Docket Item # 7
BAR CASE #2010-0175

ISSUE: Alterations and Signage
APPLICANT: King Street Subway, Inc.
LOCATION: 320 King Street
ZONE: KR/King Street Urban Retail zone

STAFF RECOMMENDATION

Figure 4: Partial Plan and North Elevation of the Storefront

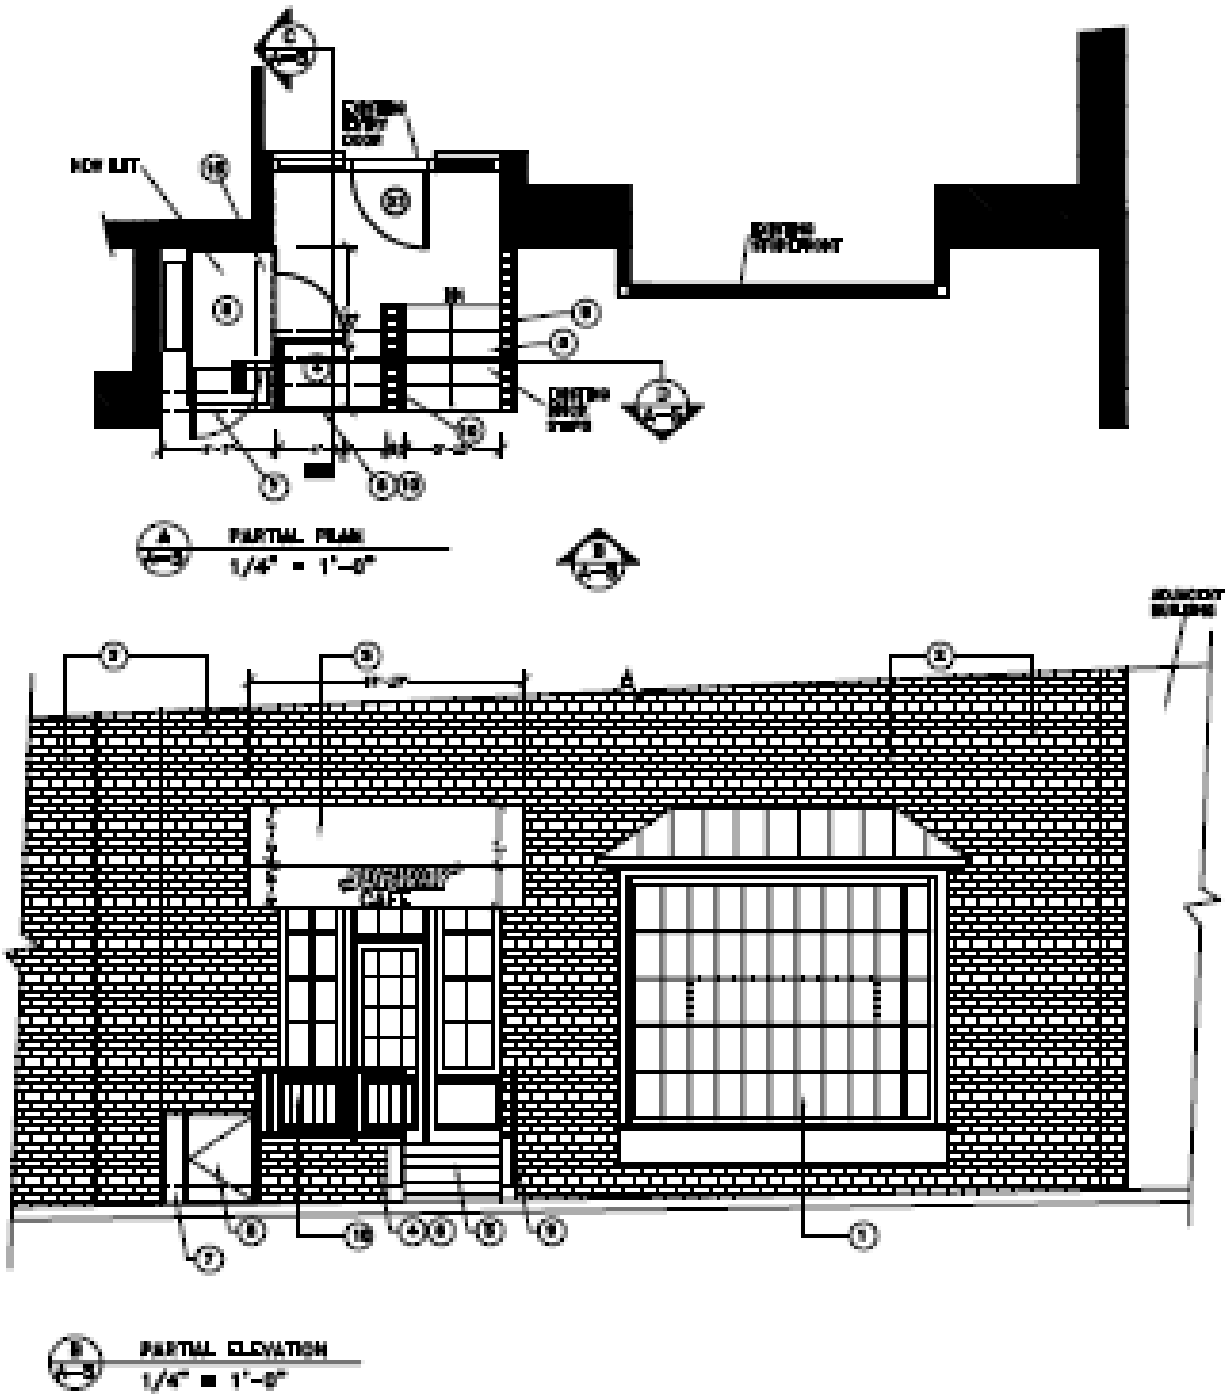
Unlike the existing stair, which is the full width of the stoop, a projection of the existing landing will be constructed on top of the east half of the existing steps to become a landing and turning area for the lift occupant. The existing brick stairs will be retained on the west half of the stoop. The new railing will match the existing metal handrail, which will also be retained on the west side of the stoop. The brick on the new portions of the stoop/stair will match the existing brick. All work will be on private property. (Staff notes that the width and handrails of the new stoop shown on Partial Elevation drawing B/A-5 is very slightly inaccurate but that this does not materially affect the ability to review the design intent of the proposed alteration. The Partial Plan A/A-5 is accurate.)

The present applicant has redesigned the steps and landing to reuse as much of the existing stoop as possible, both to reduce the expense and to avoid projecting into the public right-of-way, as the previous application for this lift did. While staff understands and supports this effort, the proposed asymmetrical design is incongruous with the symmetrical entry door beyond and has lost the softness provided by the previous planter on this urban sidewalk.

Staff, therefore, recommends that the new guardrail on the landing be pulled back approximately two feet to the south and that a small planter be created in the area above the existing steps. This would soften an area which is otherwise unneeded for disembarking from the lift or for entering the store and create an opportunity for seasonal pots or plants. (see sketch Figures #8 & 9)

Figure 5: Proposed Sections at Stoop and Steps

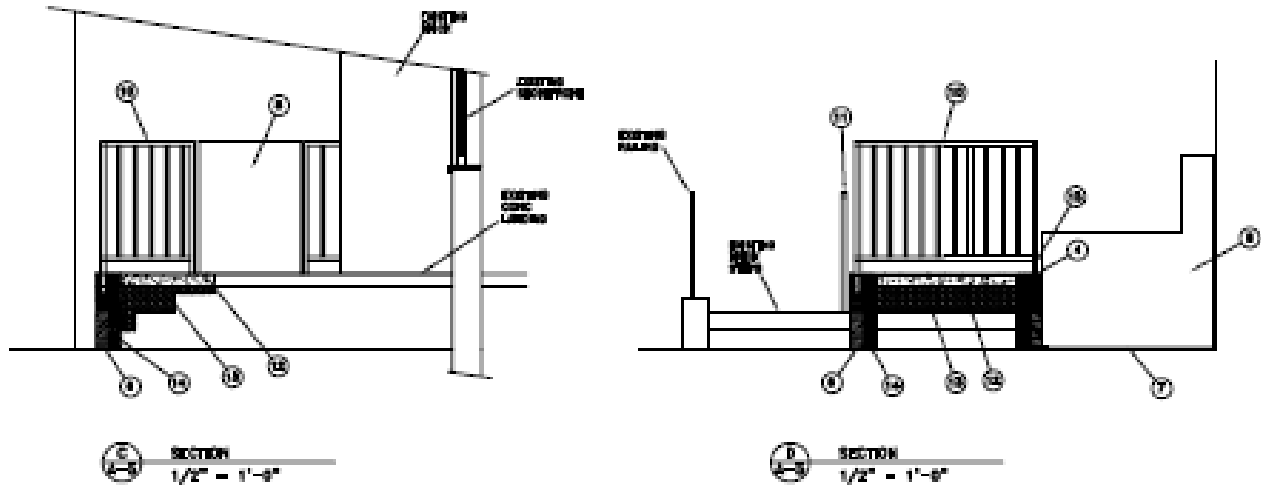
The applicant proposes to install a mechanized handicap lift immediately east of the entrance to the new restaurant. In order to accommodate the new lift and the required wheel-chair turning radius, the existing stoop, steps and handrails will be reconfigured. The lift will be located between the stoop and the existing building projection to the east, in place of the existing landscape planter. The lift will be approximately 4 feet 7 inches wide by 6 feet deep. An existing low planter wall will be removed in order to install the lift. The proposed handicap lift by Trus-T-Lift is constructed of metal.

1. That the lift and any electrical equipment serving the device be painted oxide red to match the adjacent brick, as approved by staff in the field.
2. That the awning be a canvas material and not plastic.
